ADDENDUM 2

Vestavia Hill Fire Station No. 4 Expansion

DATE: **August 12, 2026**

GREASE INTERCEPTOR DETAIL
NO SCALE

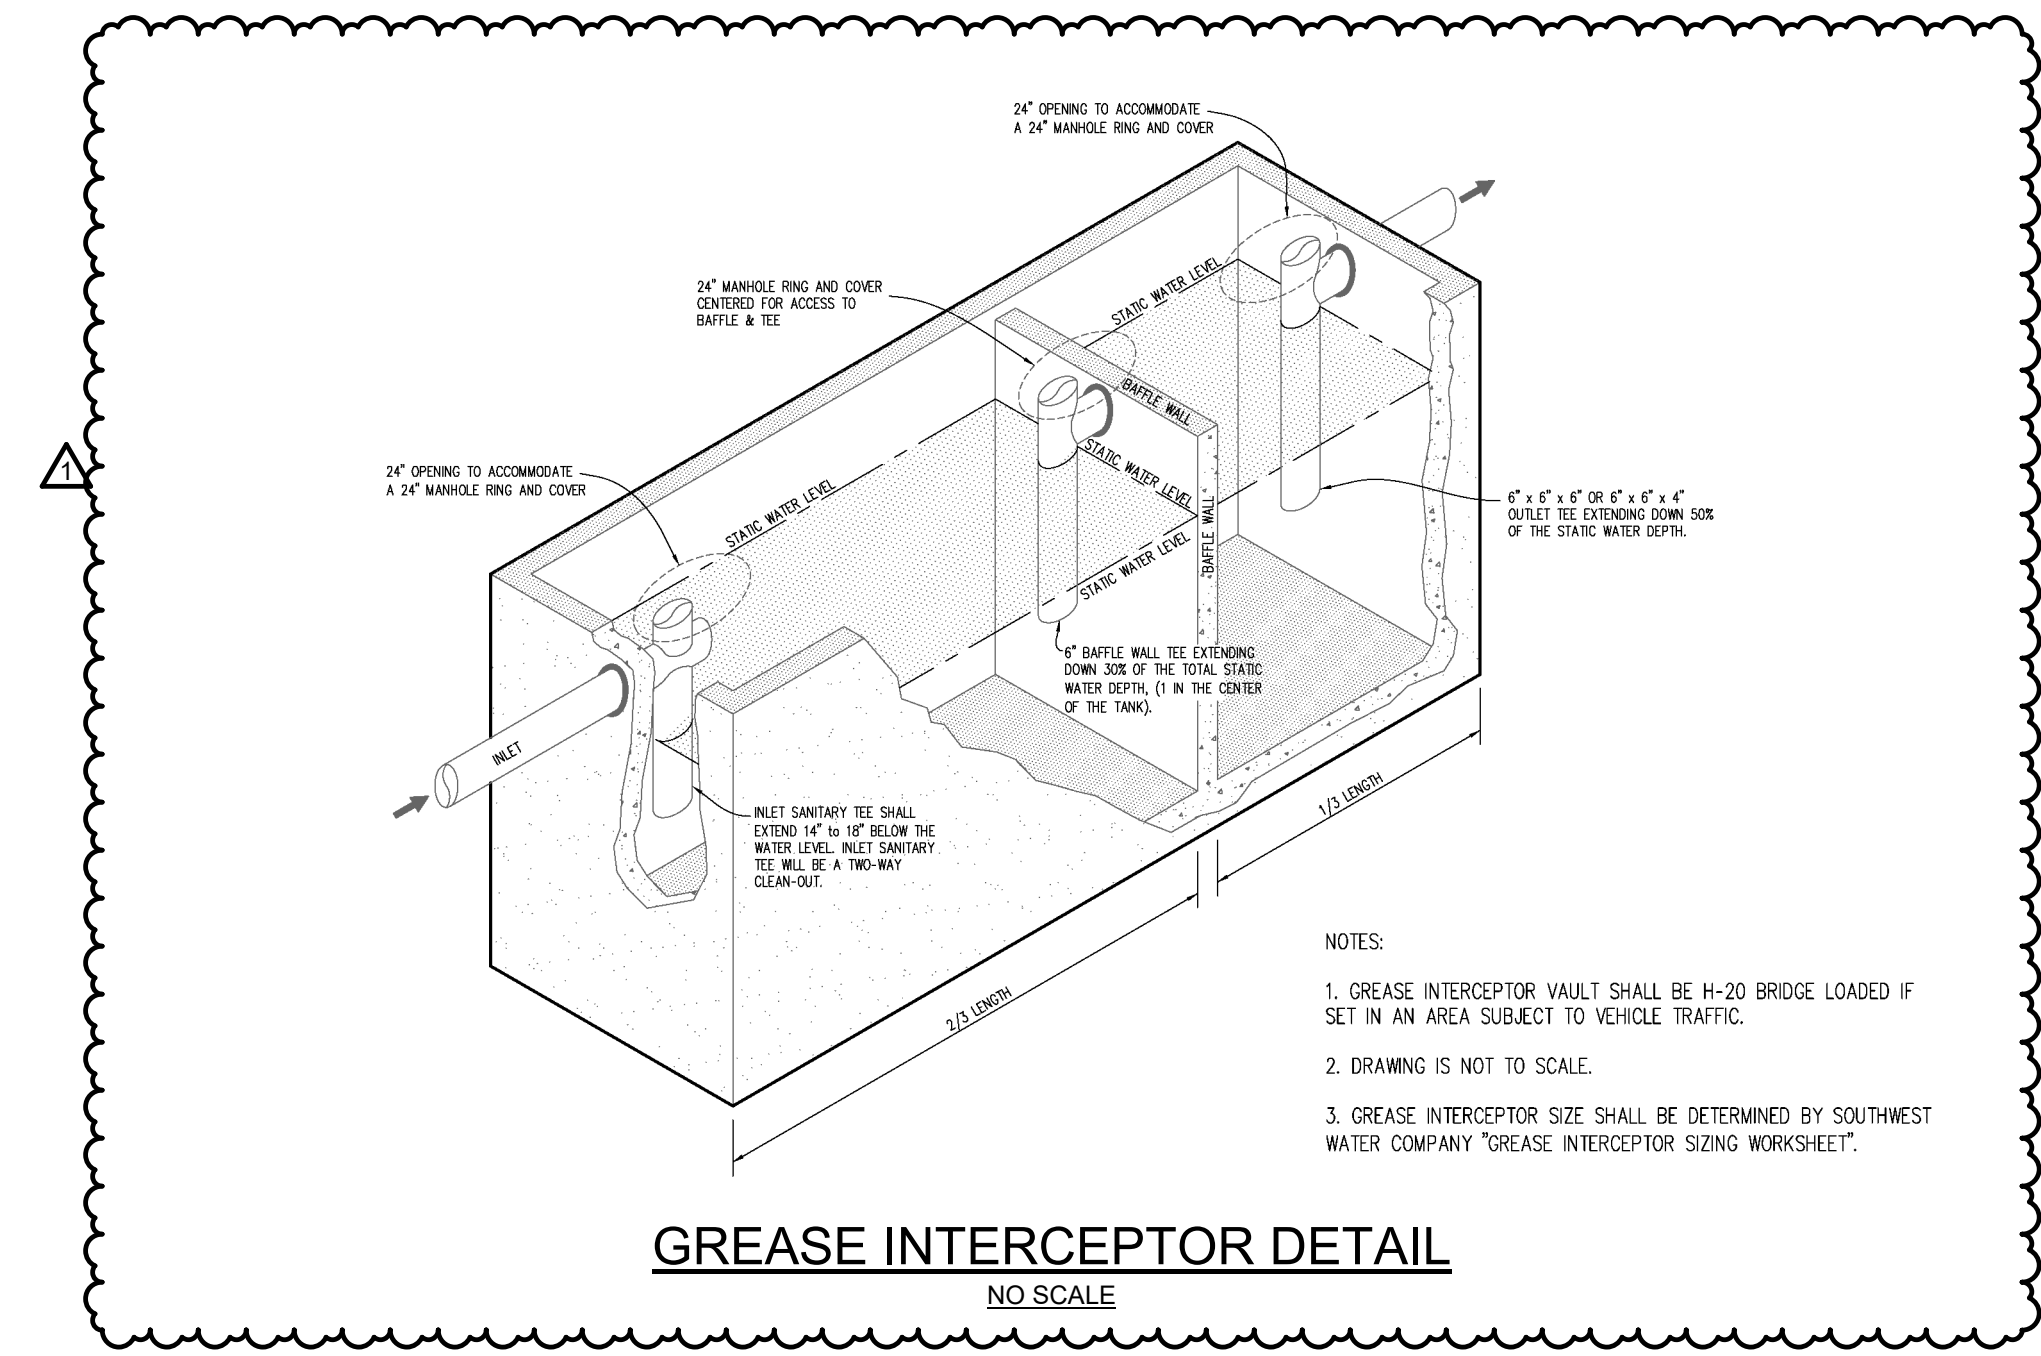
2. P-001 – PLUMBING SCHEDULES, DETAILS, AND NOTES:
 - a. Updated grease interceptor detail.
 - b. Updated grease interceptor specification.
3. P-101 – PLUMBING FLOOR PLAN
 - a. Added line showing shelter extents to pressure and non-pressure plans.
 - b. Updated grease interceptor size on floor plan.
 - c. Updated gas meter load.
 - d. Updated gas pipe routing to apparatus bay heaters.
4. P-102 – PLUMBING MEZZANINE & ATTIC FLOOR PLAN
 - a. Updated gas pipe routing to apparatus bay heaters.
 - b. Updated note regarding gas piping.
5. P-201 – PLUMBING RISERS
 - a. Updated risers to reflect floor plan changes.

3 FIRE PROTECTION - FLOOR PLAN
1/8" = 1'-0"

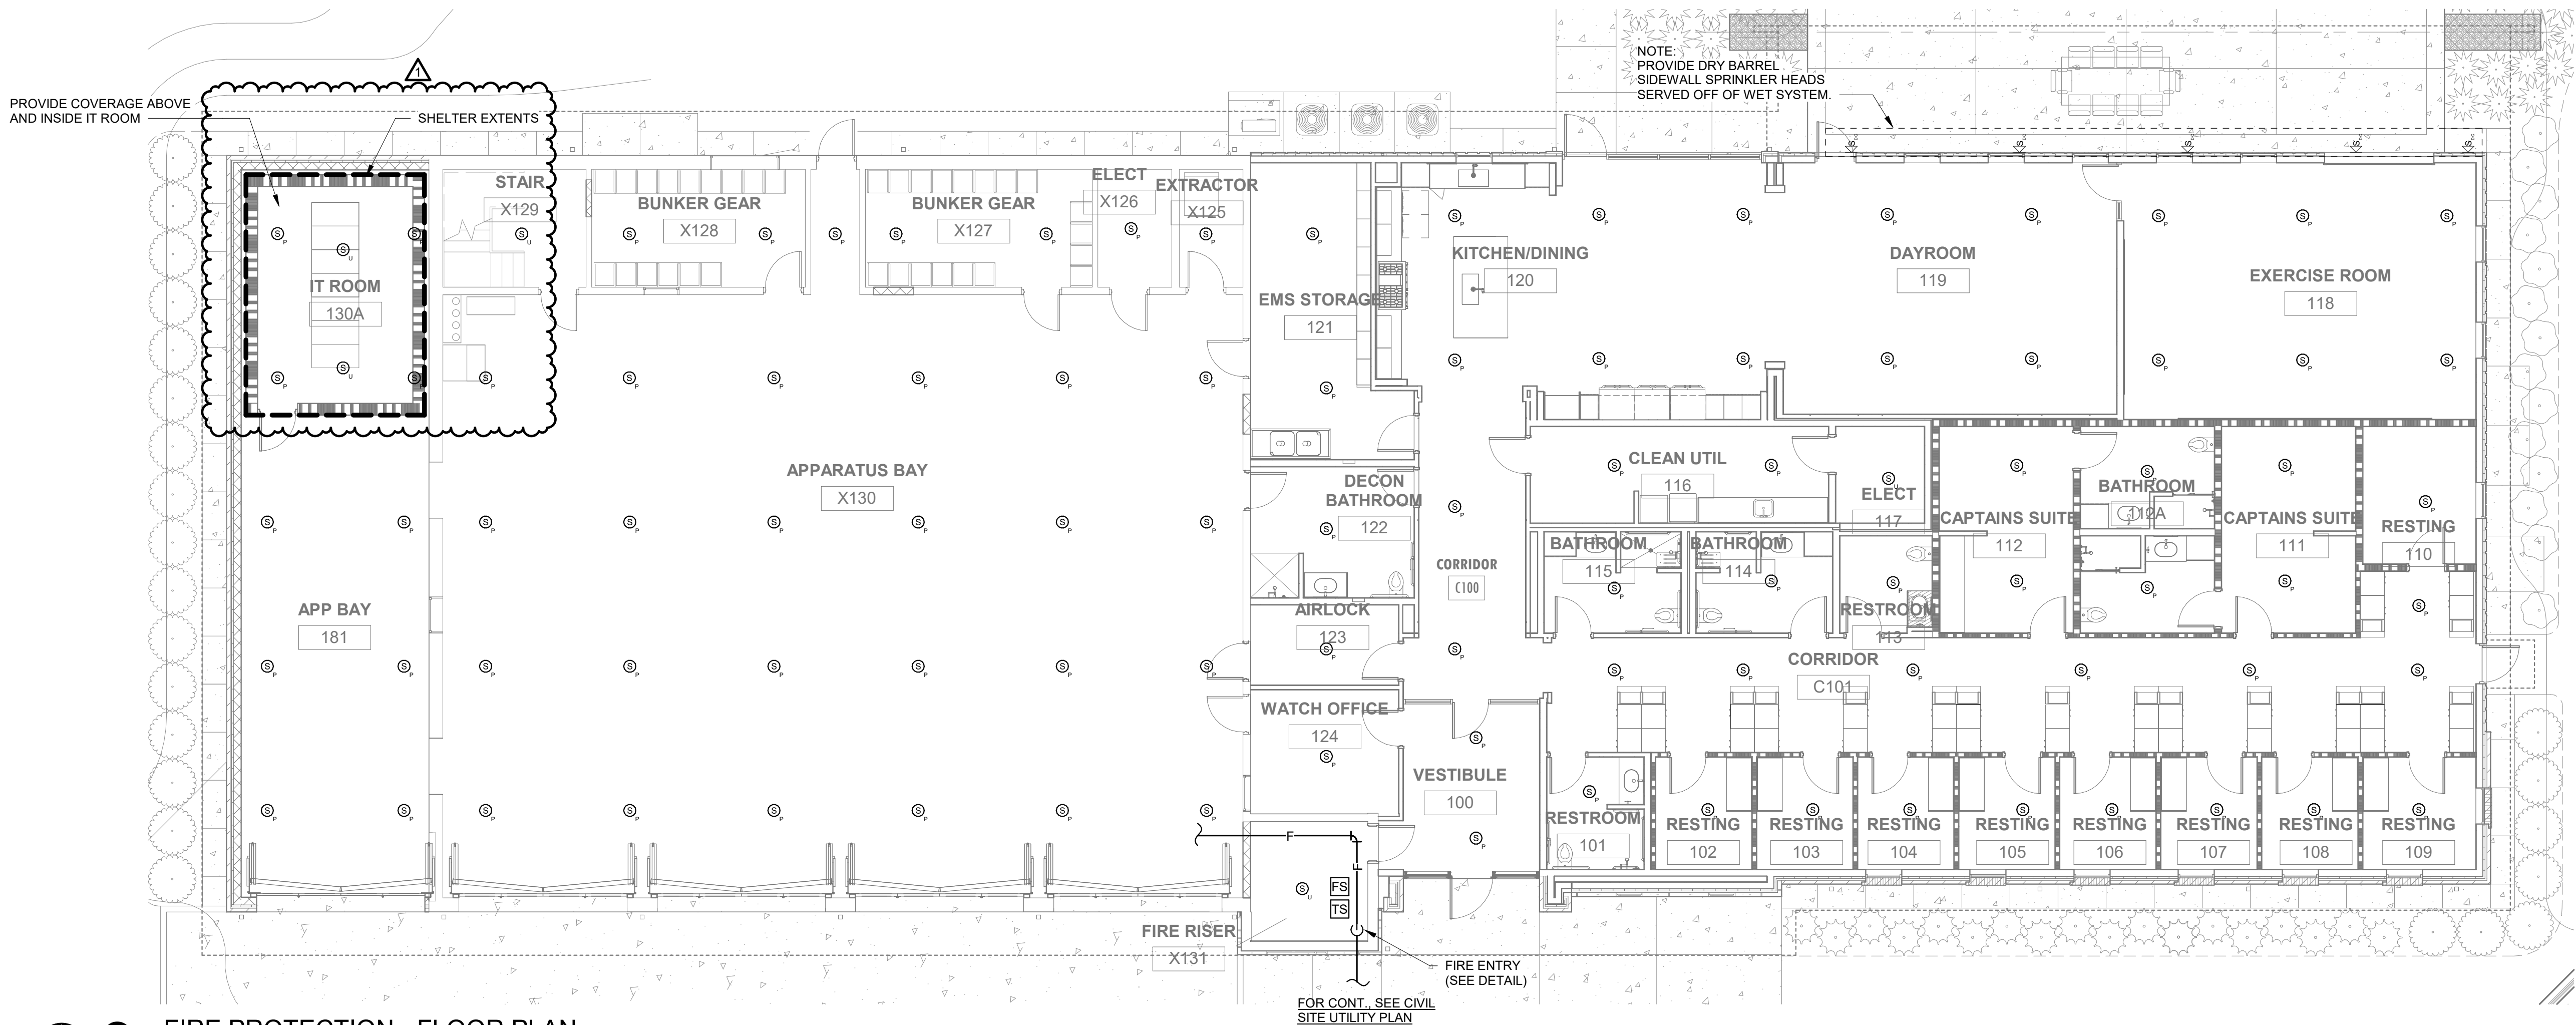
1. FP-100 – FIRE PROTECTION FLOOR PLAN:
 - a. Added line showing shelter extents.

FLOOR PLAN LEVEL 1 - ALERT SYSTEM
① DEVICE LAYOUT PLAN
N.T.S.

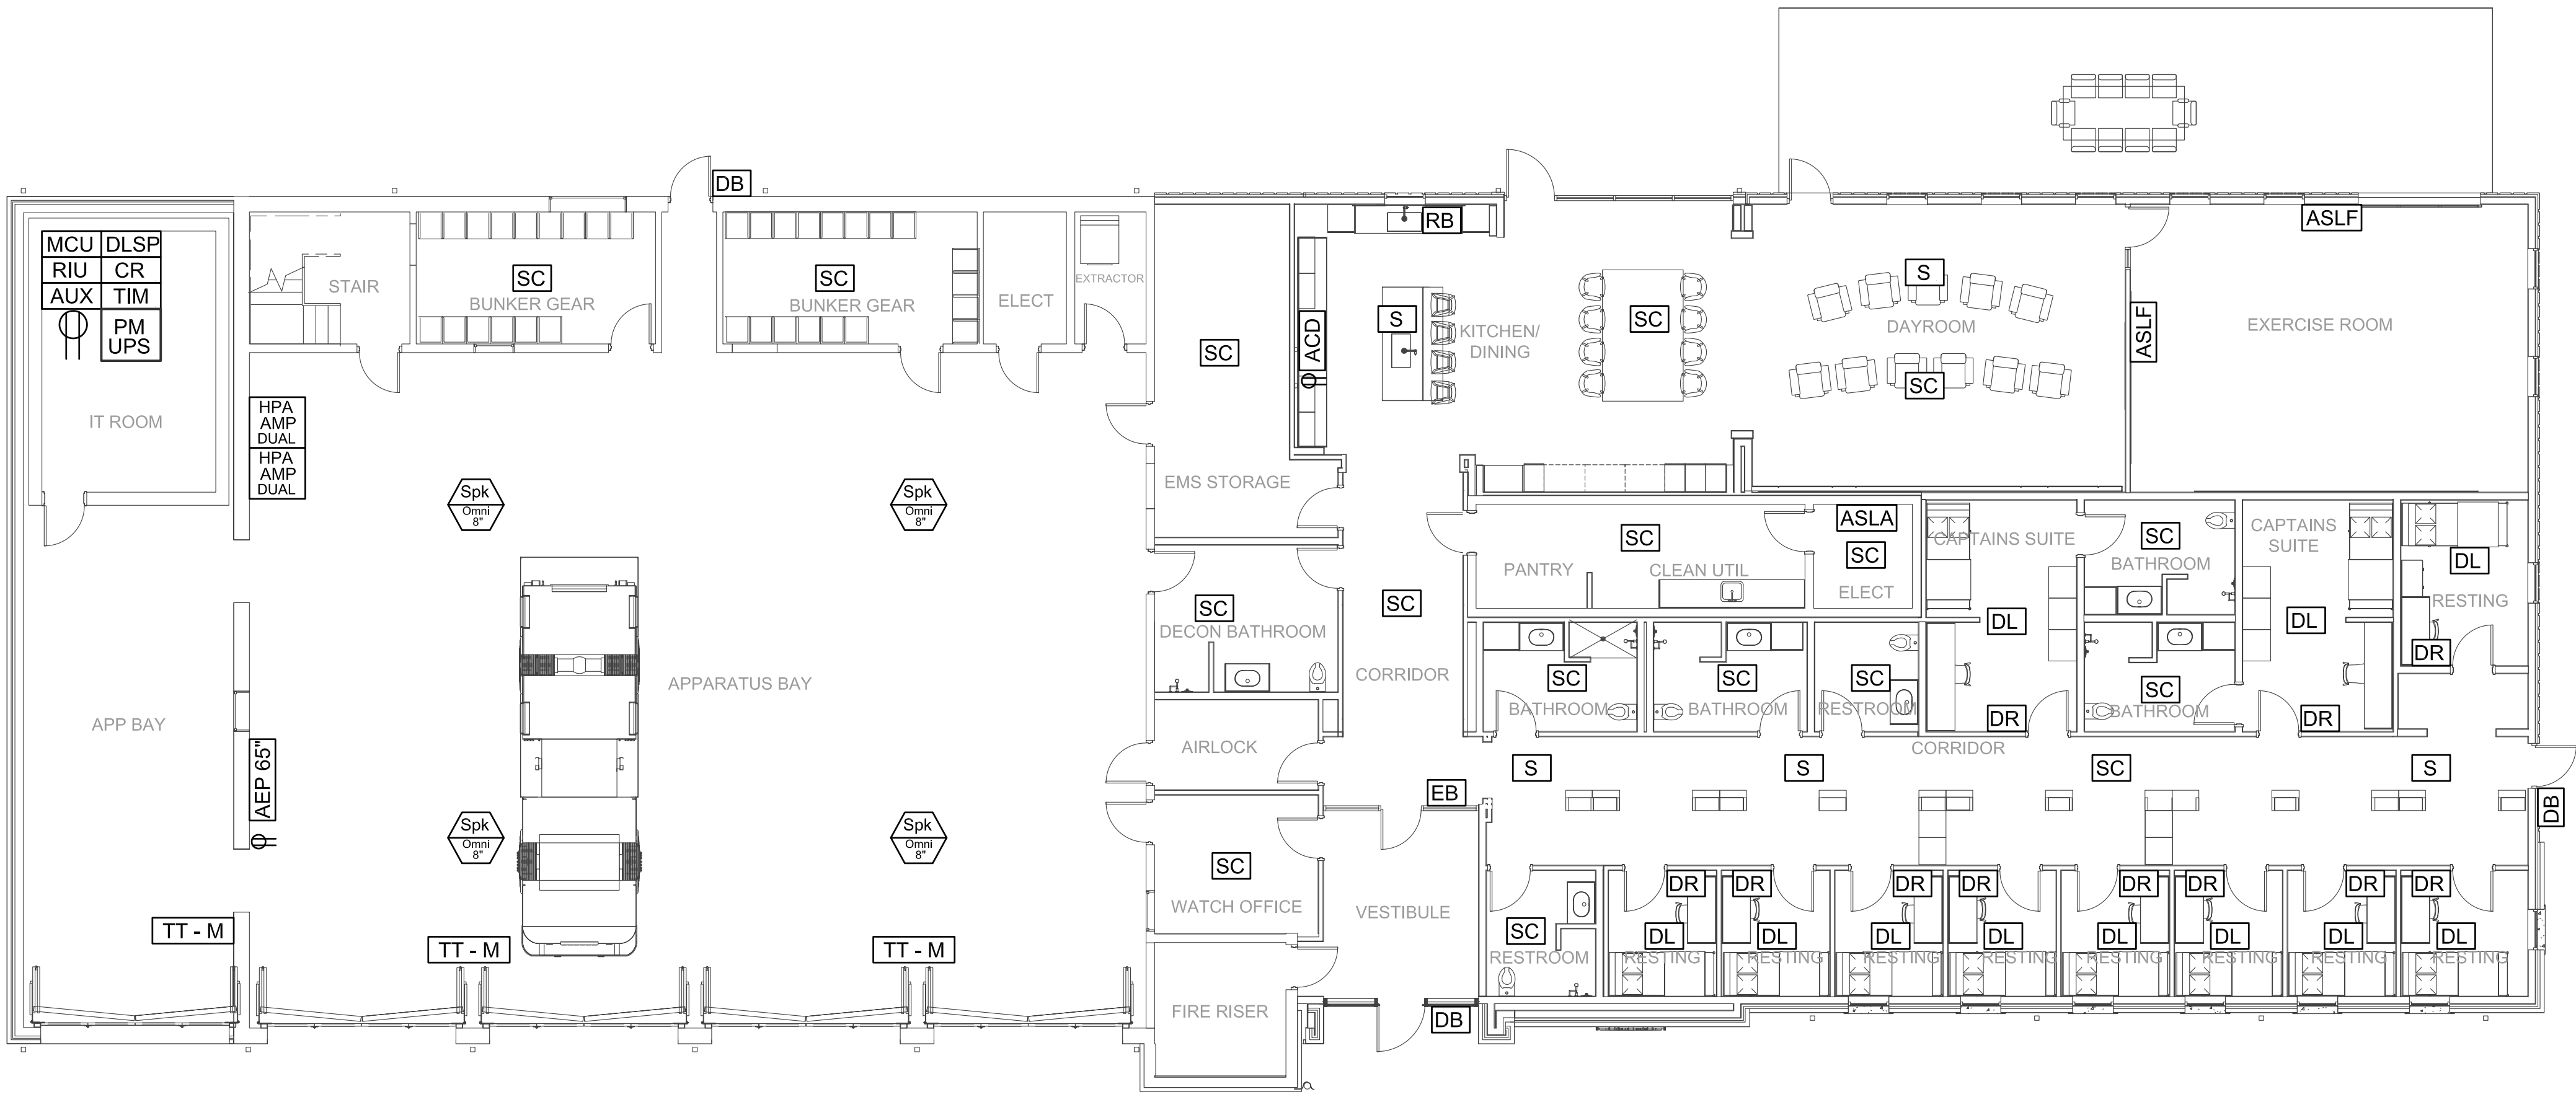
- a. Added note on floor plan showing the Storm Shelter Boundary.
10. E-602 – FLOOR PLAN – ALERT SYSTEM DEVICE LAYOUT PLAN:
 - a. Added drawing for alert system device layout to coordinate with Alert System Shop Drawings.
